MONTGOMERY COUNTY HISTORIC PRESERVATION COMMISSION
STAFF REPORT

Address:	7213 Spruce Ave., Takoma Park	Meeting Date:	03/22/17
Resource:	Contributing Resource Takoma Park Historic District	Report Date:	03/15/17
Applicant:	Dana Perrone	Public Notice:	03/08/17
Review:	HAWP	Tax Credit:	N/A
Case Number:	37/03-17R	Staff:	Dan Bruechert
Proposal:	Fence, Deck, and Hardscape Alteration

Tree Survey
7213 Spruce Avenue

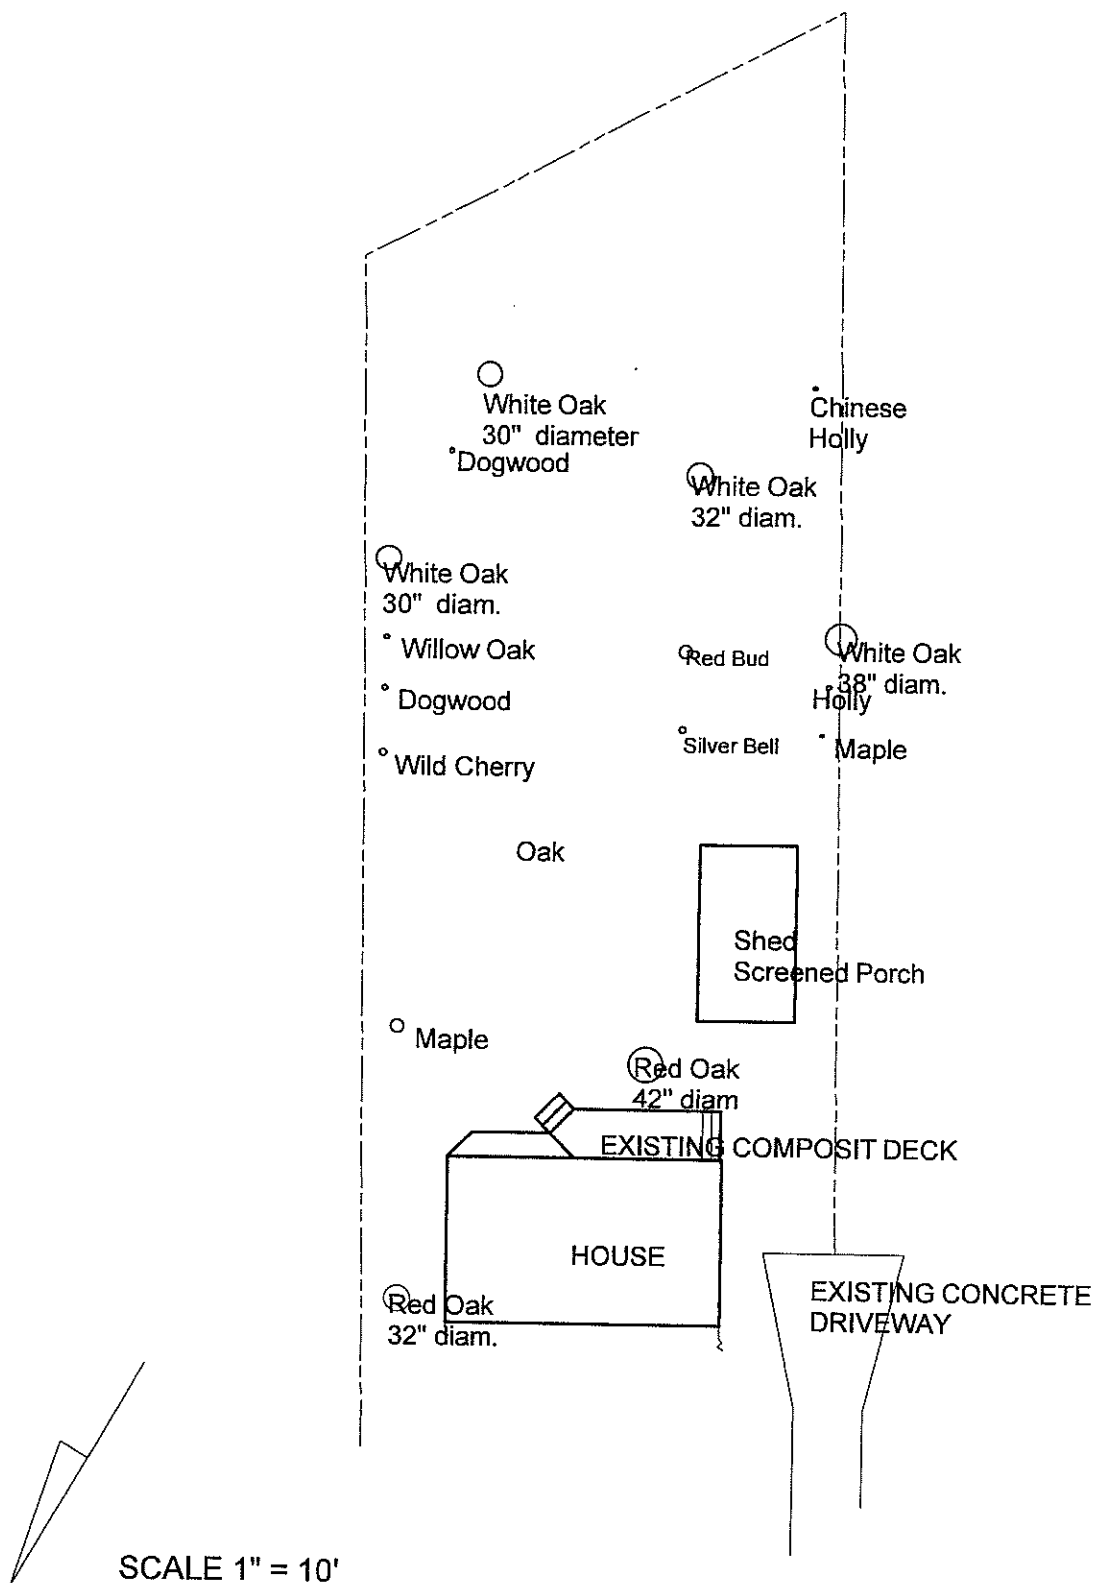
**MUST USE AIR SPADE TO REACH SUB GRADE DEPTH OF PROPOSED STONE WALL.
NO ROOTS OVER 2" TO BE CUT. MUST PROVIDE SPACE BEHIND WALL IF ANY
ROOTS GREATER THAN 2" ARE PRESENT.**
